ADDENDUM #3

August 27, 2025

**CRAWFORDSVILLE READINESS CENTER MODERNIZATION
INDIANA NATIONAL GUARD
CRAWFORDSVILLE, INDIANA**

IFB NO: MDI-SAB-26-B-013

ABI1
A323

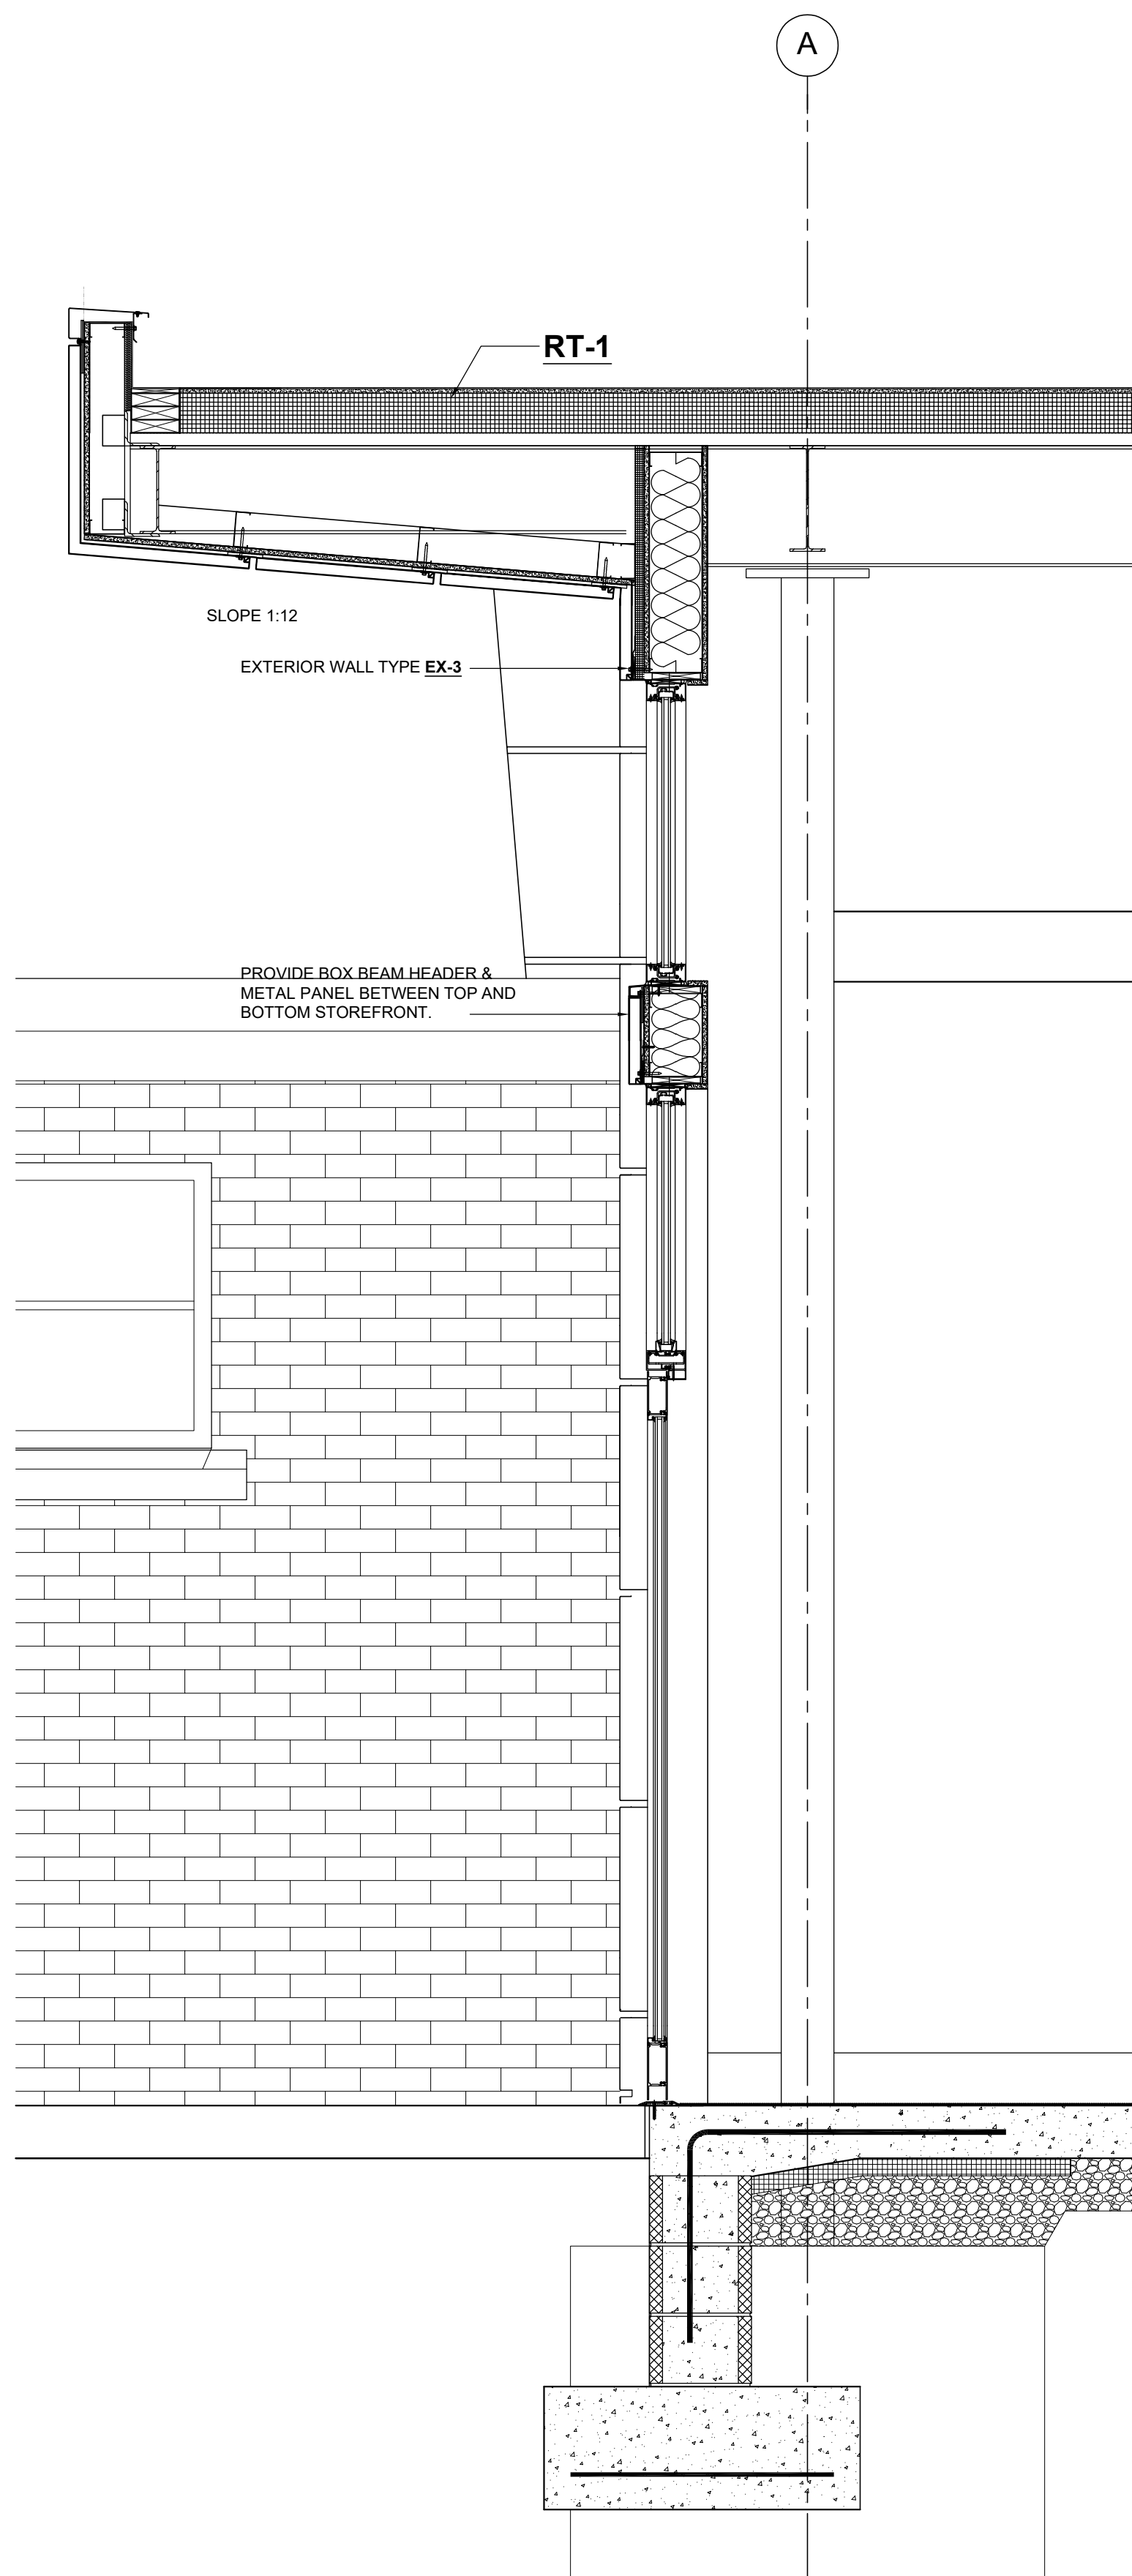
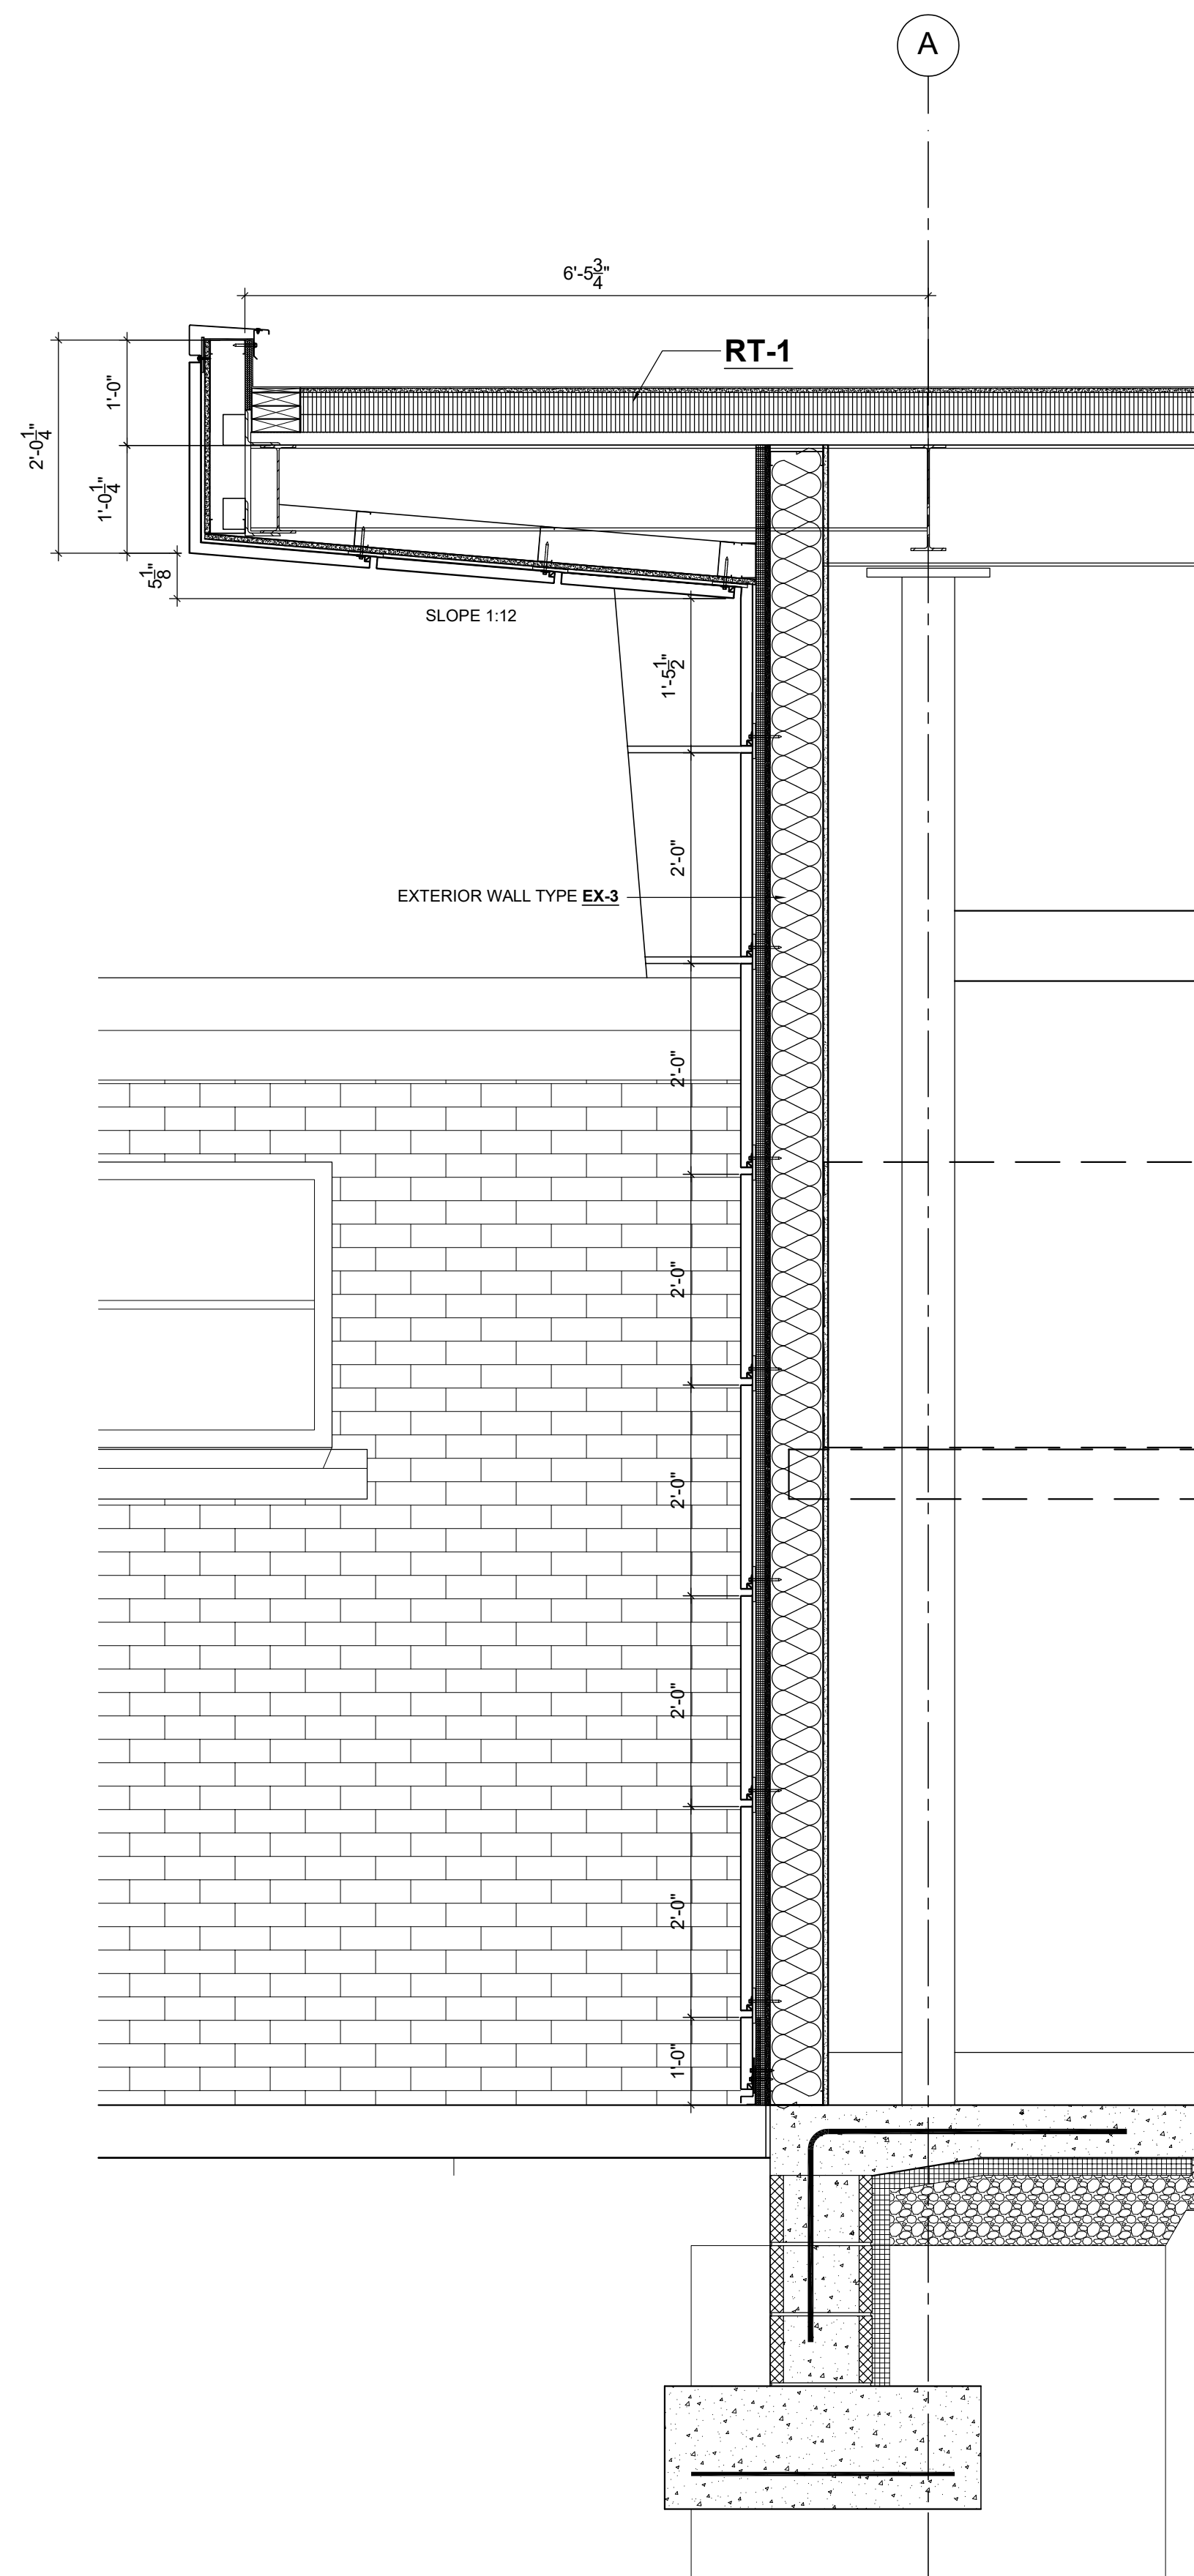
- Response: **1600 SSG is acceptable in this location.**
25. Question: At Alternate #1, entrance frame type 'S17' is shown with a 1'-0" horizontal separation creating a transom window above the door frame. Can you clarify what this structure is? Will it need to be wrapped with Brake metal?

- Response: **This is a metal box beam header, wrapped in aluminum to match the storefront. Refer to A323 attached to this addendum.**
26. Question: Referring to the previous section cut, doors 100C are shown at the interior and are also referenced as Frame 'S17'. However, it appears that the interior frame S17 runs the full height of the opening with no 1'-0" horizontal separation. This seems to match the elevation of 100C shown on section 6-6 on the same sheet (please see below). Should this S17 run the full height with no interruption?
